BLACK HORSE PIKE REGIONAL SCHOOL DISTRICT
Highland HS 2025 LMC Corridor & Classroom Renovations (GA# 23-73)
Addendum #1– Cover Sheet
January 9, 2025

BLACK HORSE PIKE REGIONAL SCHOOL DISTRICT
Highland HS 2025 LMC Corridor & Classroom Renovations (GA# 23-73)
Addendum #1 - Narrative
January 9, 2025

BLACK HORSE PIKE REGIONAL SCHOOL DISTRICT
Highland HS 2025 LMC Corridor & Classroom Renovations (GA# 23-73)
Addendum #1 – Contractor Questions and Answers

**ALTERNATE BID
MECHANICAL
DEMOLITION
FLOOR PLAN
M1.1A**

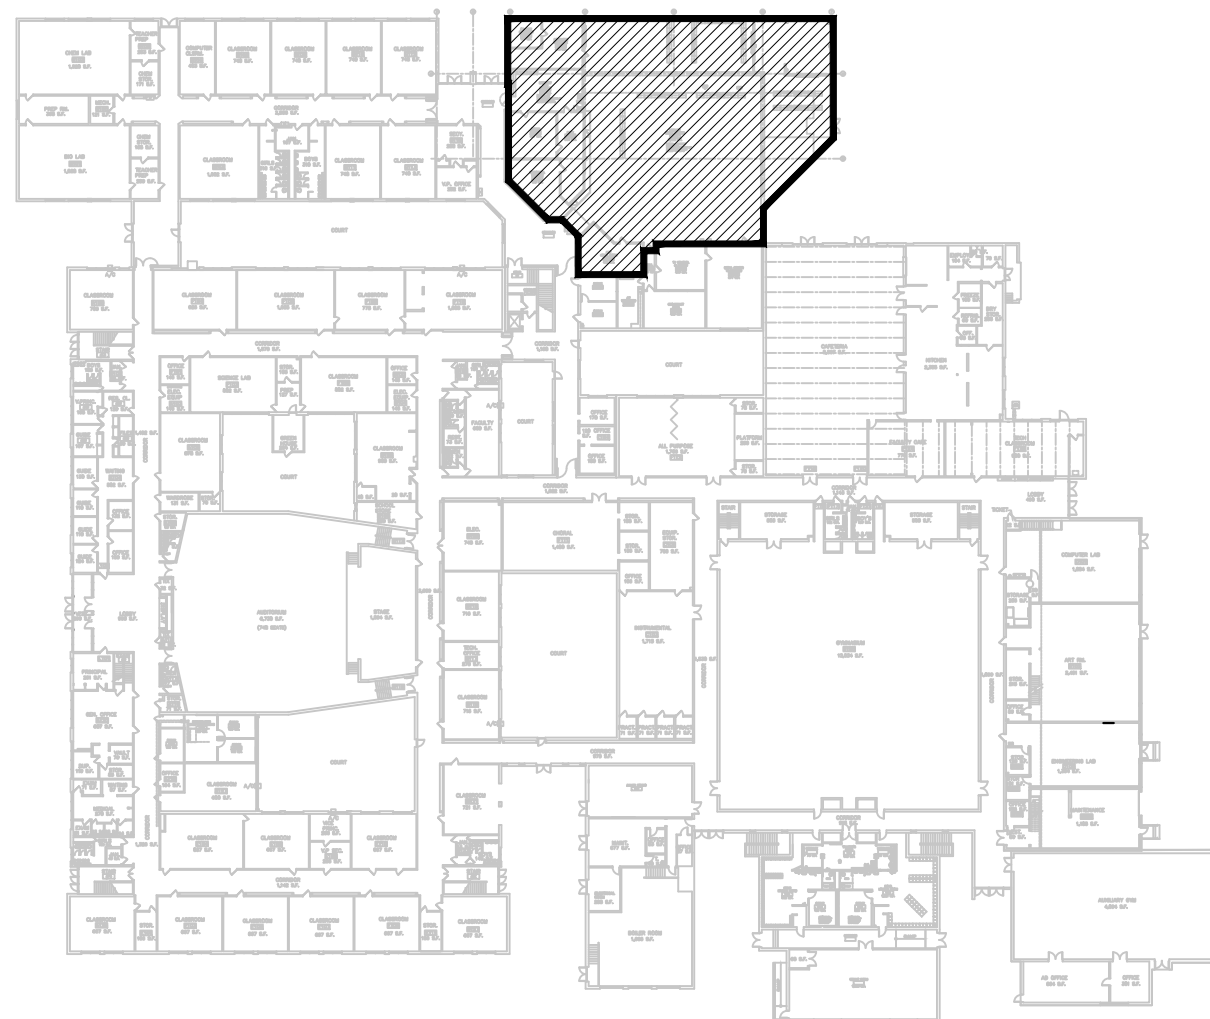
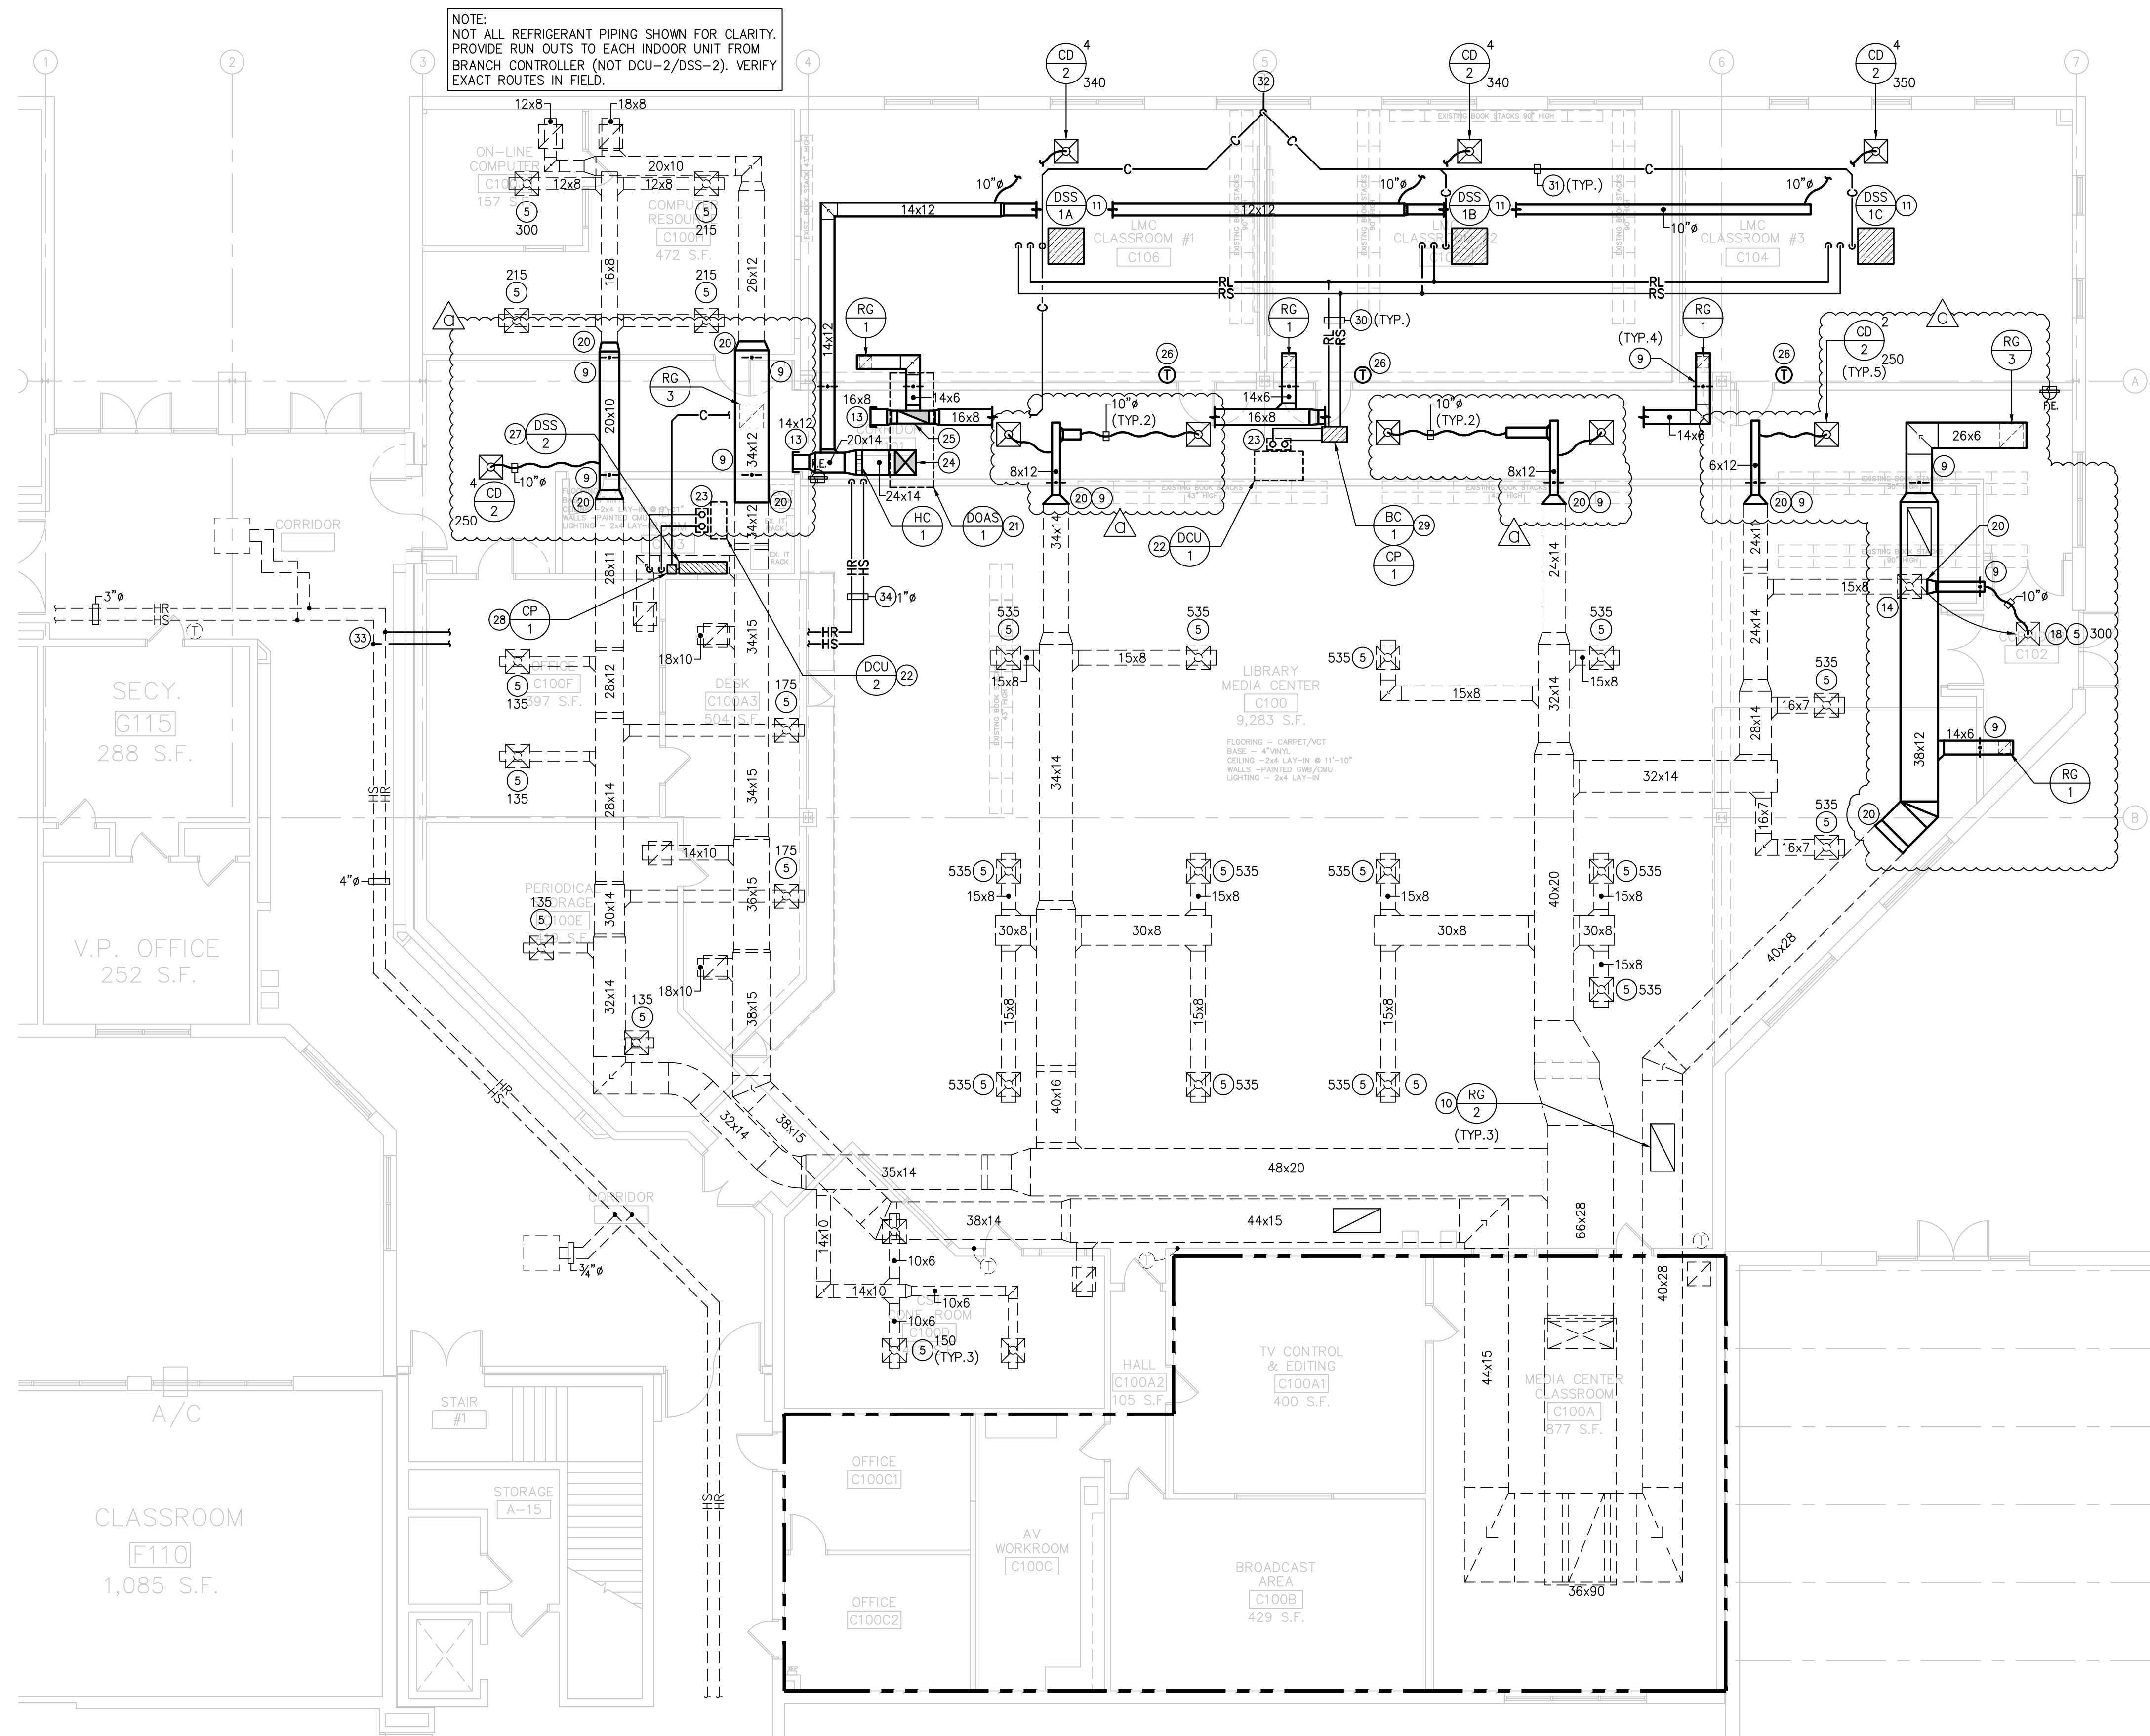
- 2) On M1.1 and M1.1a demo prints there are some missing branch duct sizing needed for patch work (mech sheet note #3). The CFM information is missing for (mech sheet note 5) on several of the GRD's. Needed to rebalance. I also need the existing GRD's CFM for rebalancing as called out in note 5.

Answer: Please see Addendum Narrative for answer.
